June 10, 2011

Subject: **Joint Permit Application No. 10-1256
Responses to the Corps Request for Additional Information (RAI)
Virginia Electric and Power Company (Dominion)
North Anna Power Station - Proposed Unit 3
Louisa County, Virginia**

Figure 1 – Streams for Preservation South of Haley Drive

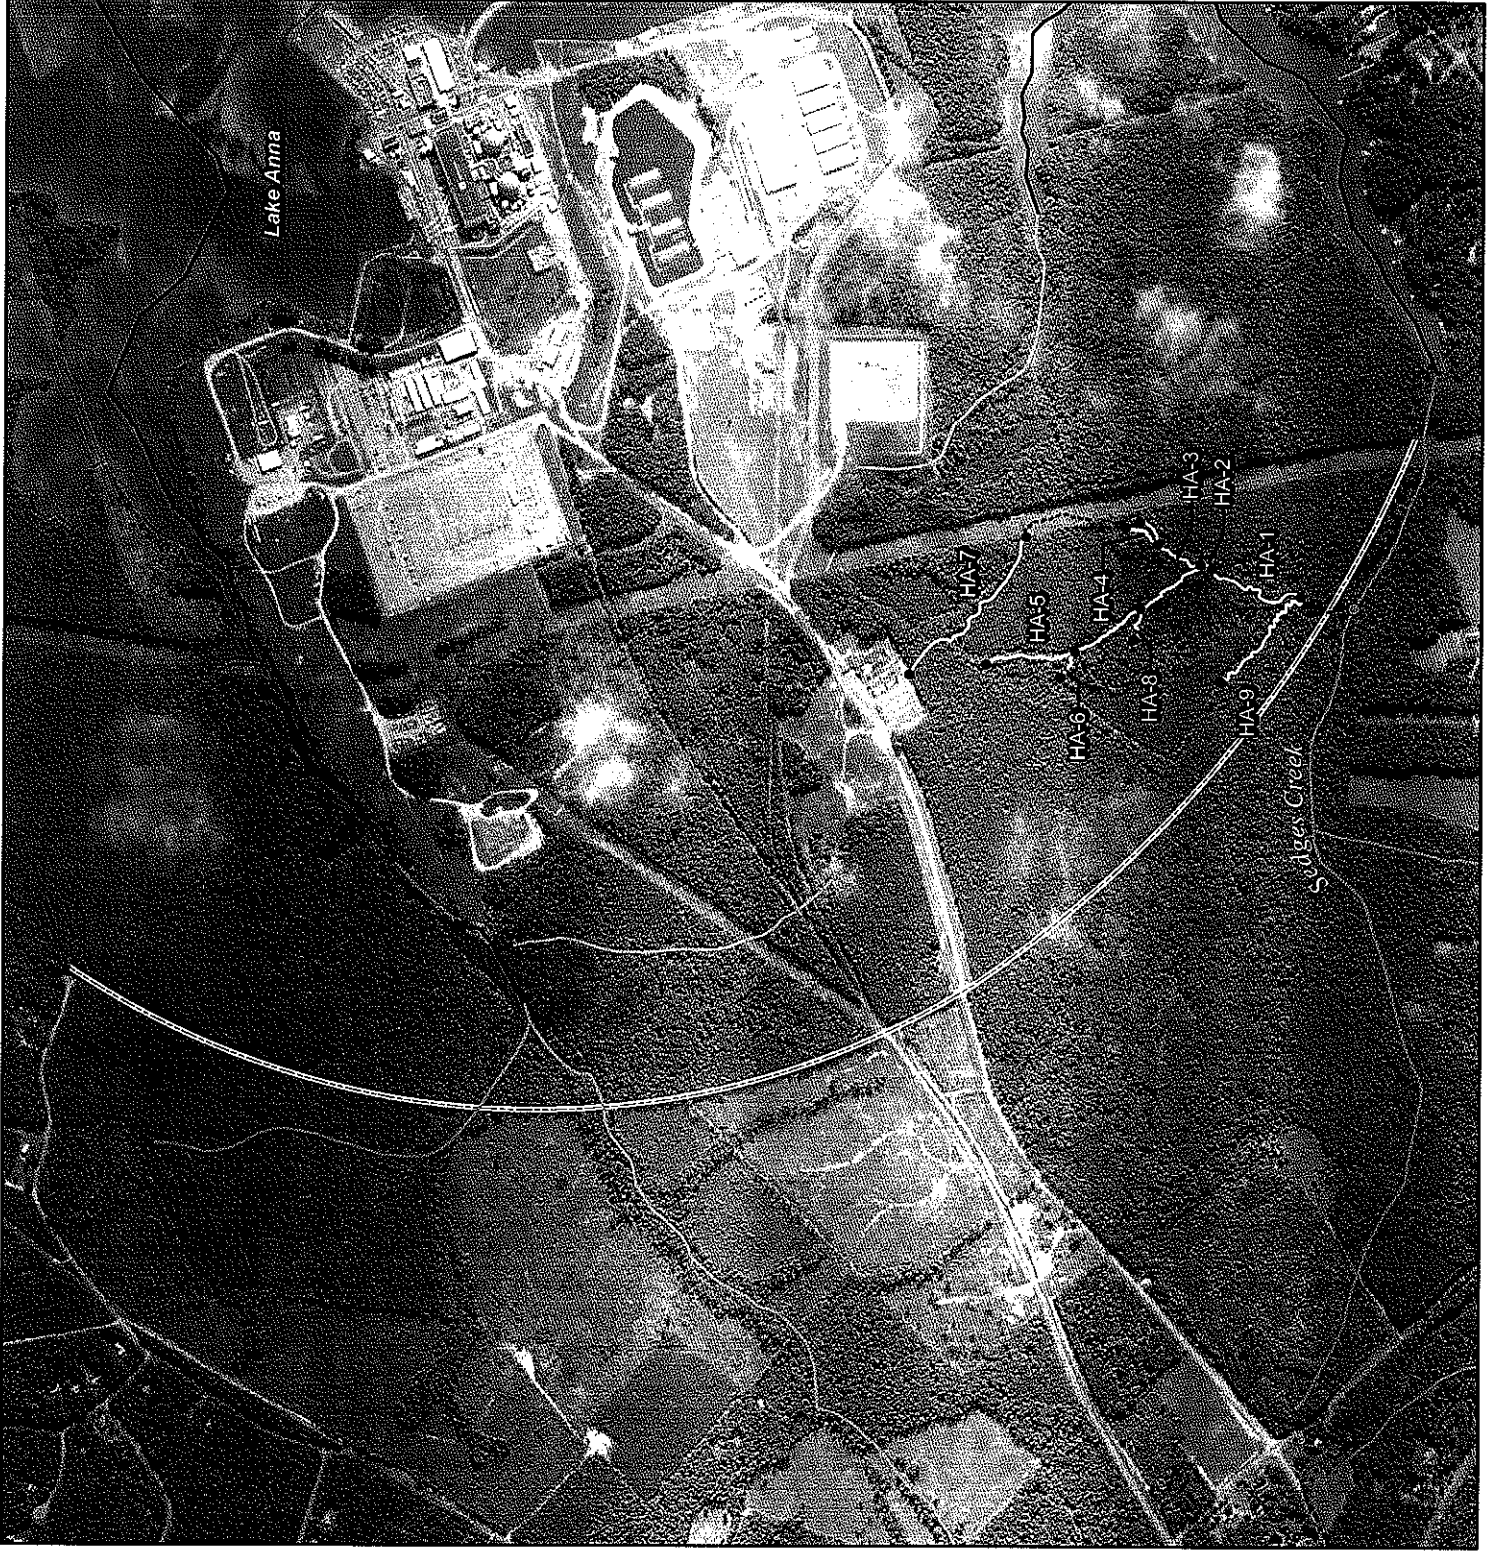
USACE Comment 5 – For preservation streams HA-1 through HA-9, please clarify the distance between the most downstream point of the preservation reach and the confluence with receiving waters. What is the nature of the property that these reaches flow through prior to entering those receiving waters? What is the ownership of the property? What possible activities may occur within the property between the preservation reach and the receiving water? Will all this area be contained within the NAPS exclusion area? Please

provide a diagram or general map that depicts the extent of the exclusion area surrounding the NAPS.

Dominion Response - The distance between the most downstream point of each proposed stream preservation reach and the receiving waters is presented in the table below.

From the point of confluence between the HA system and Sedges Creek, Sedges Creek flows an additional 1,543 feet to the Waste Heat Treatment Facility. The entirety of Sedges Creek is outside of the Exclusion Area Boundary (Figure 1).

Due to the location of the proposed stream preservation reaches, deed restrictions to be recorded on the property, and limitations enforced by the U.S. Nuclear Regulatory Commission (NRC) regulations, the proposed stream preservation reaches located within the Exclusion Area Boundary will not be impacted by future development activities at the Station. Dominion owns almost all of the land traversed by the HA system. A relatively short distance (approximately 150 feet) of stream channel runs outside of the Exclusion Area Boundary before entering Sedges Creek. The property on either side of Sedges Creek is owned by a local hunting organization. The terminus of each stream system proposed for stream preservation is presented in the table above. Figure 1 depicts the location of the proposed stream preservation reaches and their relationship to the Exclusion Area Boundary.

INFILTRATION TRENCH TYPICAL CROSS SECTION

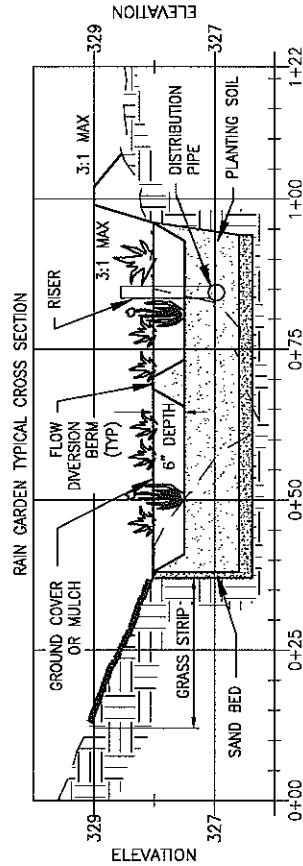
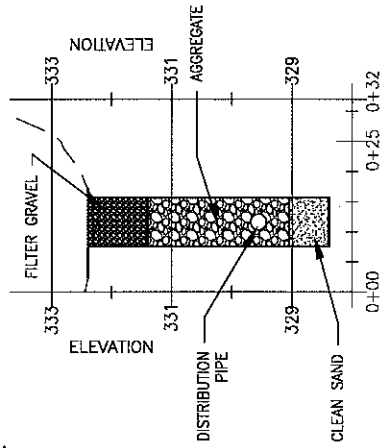
USACE Comment 3 – Provide a conceptual plan for a constructed measure to reduce velocity and to prevent possible introduction of contaminants into preservation stream reach HA-7.

Dominion Response - A conceptual plan to intercept surface water generated from the parking lot at the North Anna Nuclear Information Center (NANIC) prior to its flow into preservation stream reach HA-7 has been developed (Attachment C). This design will be capable of treating the first 0.5 inches of runoff per Virginia Department of Conservation and Recreation (VDNR) standards. The first 0.5 inches represents the “first flash” of stormwater containing the highest concentrations of stormwater contaminants. The proposed design will be a shallow, constructed depression that will be planted with deep rooted native plant and grass species and an interceptor trench. The design will capture runoff from the NANIC parking lot and divert the water into a rain garden where the water can slow down and slowly infiltrate into the ground. After installation of the proposed rain garden and interceptor trench, the stormwater will be of higher quality than the stormwater currently making its way into the channel.
